To the Columbia County Commissioners,

The topic of my concern is the tall cylindrical structure standing alone in the field in the site rendering:

My search in the Columbia County Staff Report in DR 21-03 MOD & CU 23-11 NEXT Facility (RIPD/PA-80) for review criteria and findings **related to the proposed flare stack** has been futile. In the absence of flare stack information, the County's findings raise some red flags.

Note:  
A magnifying glass  
will confirm that the  
label says:  
**PROPOSED FLARE**

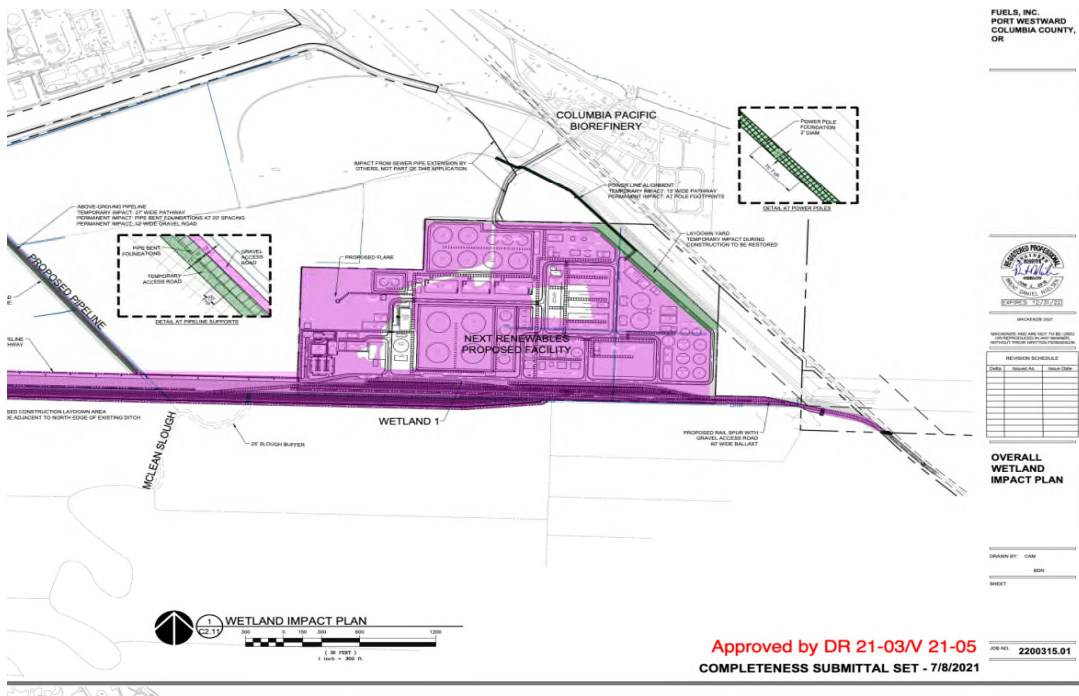
Has the County investigated possible negative impacts of the flare (flare stack) on residential uses?

What steps has the County taken to address the possible negative impacts of the proposed flare stack

on people who are looking out their living room windows? Sitting on their decks and porches? Enjoying their gardens? Being cared for, indoors and outdoors, at the monastery?

Which communities and neighborhoods would see or hear the flare stack activity?

**Finding 17** on pg 16 of 48 does not address the proposed flare (flare stack). The site rendering and other drawings fail to provide suitable scale and dimensions of the proposed flare stack. Furthermore, the finding states, "Noise sources for the approved facility will utilize applicable mechanisms to limit volumes to no more than 85 decibels at the property line." Not only are the scale and the dimensions of the flare stack missing, but the County has not required any details from the applicant on how the flare stack will meet noise standards.

The County has failed to ascertain from NEXT Renewable Fuels how the flare stack will complement the character and development of the surrounding rural area. Addressing the flare stack separately is appropriate because it would be a landmark due to its height, flame and smoke. The County has failed to investigate whether the flare stack would interfere with the residential and tourist uses of the surrounding rural area. This Columbia River corridor has an extensive tourism component. Some residences within the vicinity of Port Westward are vacation rentals to take advantage of the incredible views of the Columbia River.
